ZX Spectrum Issue 1 and early Issue 2: Spider / Dead Cockroach timing fix for ULA 5C102

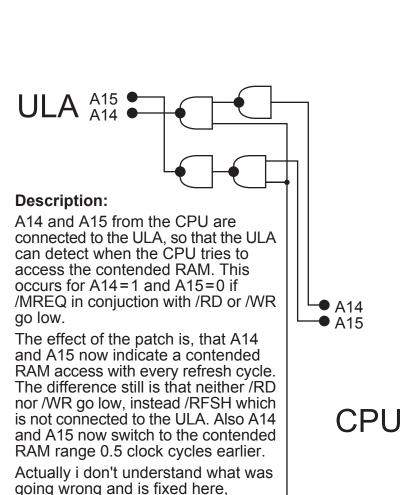
Note: the 47LS00 is shown as

mounted: upside down!

especially because setting the I register to this range causes problems on other

machines. (Note: the I register is put on A8-A15 in the refresh cycle.)
